April 1, 2019
BOARD OF COUNTY COMMISSIONERS
ORANGE COUNTY, FLORIDA
Addendum No. 2, IFB Y19-744-RC
MAGNOLIA PARK & ECO-TOURISM UTILITY EXTENSION

ELECTRICAL - PANEL SCHEDULES
 UTILITY EXTENSION
MAGNOLIA PARK ECO-TOURISM
 OC CAPITAL PROJECTS
 ORANGE COUNTY, FL

LIFT STATION DETAIL SHEET
 UTILITY EXTENSION
MAGNOLIA PARK ECO-TOURISM
 OC CAPITAL PROJECTS
 ORANGE COUNTY, FL

The wetwell shall be manufactured of fiberglass reinforced polyester (FRP) of depth and diameter as shown on the lift station elevation detail. The wall thickness shall be adequate for the depth of the wetwell to maintain the H-20 LOAD RATING.

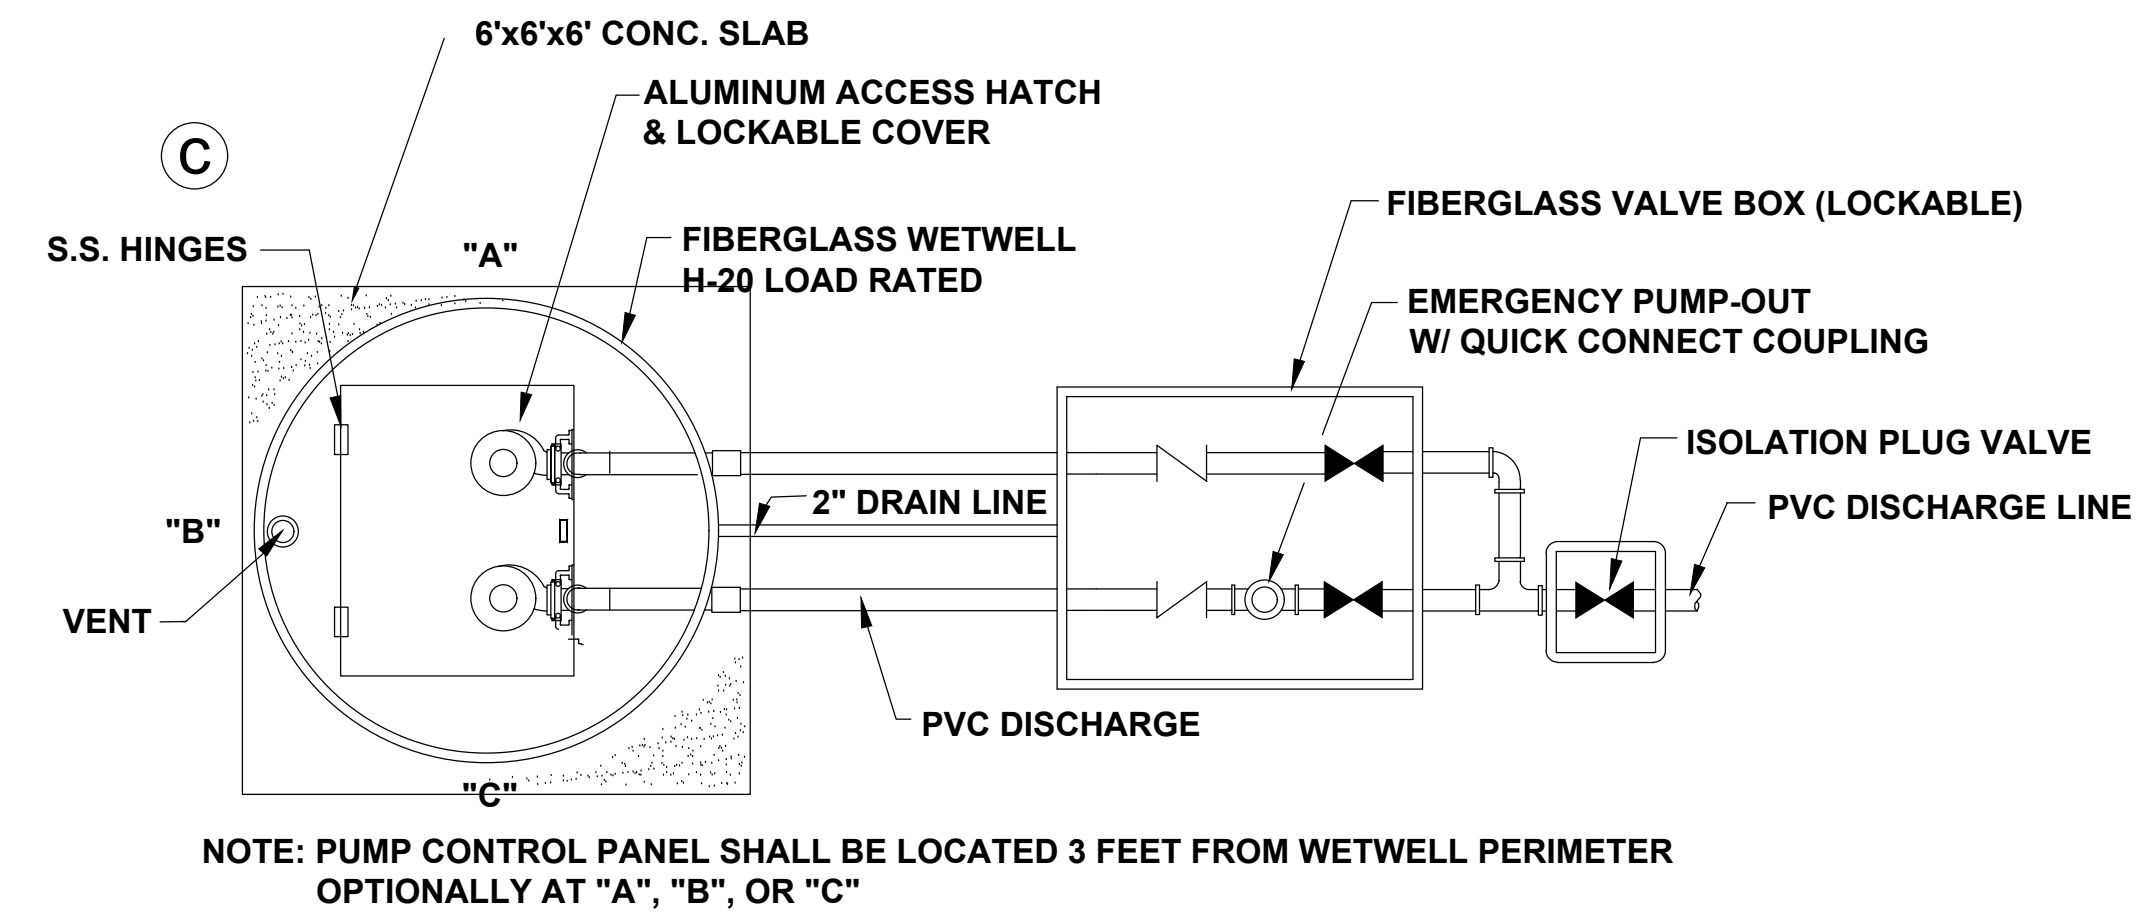
1. **Question:** On plan sheet C404, please confirm the uni-strut, caps and posts are to be galvanized and not stainless steel.

Answer: Please see revised Sheet C404 dated 3/25/2019 and labeled this addendum as noted below in part C
